Groundwater Transfer Review Summary Form

Transfer/PA # T- 13693

Application: T-13693

Applicant Name: Case Family LLC

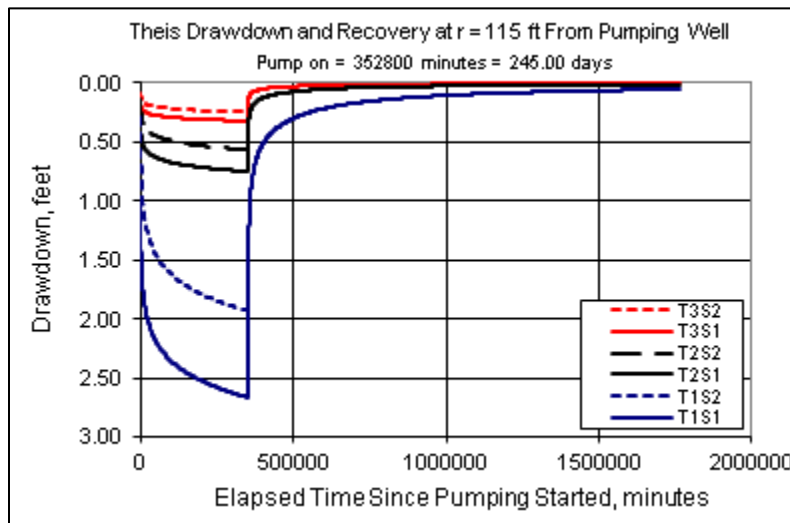
4. a) Will this proposed change, at its maximum allowed rate of use, likely result in an increase in interference with **another ground water right**?
☒ Yes ☐ No Comments: Proposed APOA LINN 4614 is significantly closer to nearby well LINN 4606 than the currently authorized POA well. LINN 4606 is the authorized POA under groundwater claim GR-919. The mapped locations of these wells puts them at 115 feet away from one another.

☐ Yes ☒ No If yes, explain: Given the fairly low authorized rate for GR-2289 (0.4456 CFS) and the combination of high transmissivity and high storativity of the unconfined alluvial aquifer, anticipated drawdown resulting from pumping at LINN 4614 is minimal at LINN 4606, with a range of scenarios producing less than 3 feet of likely drawdown.
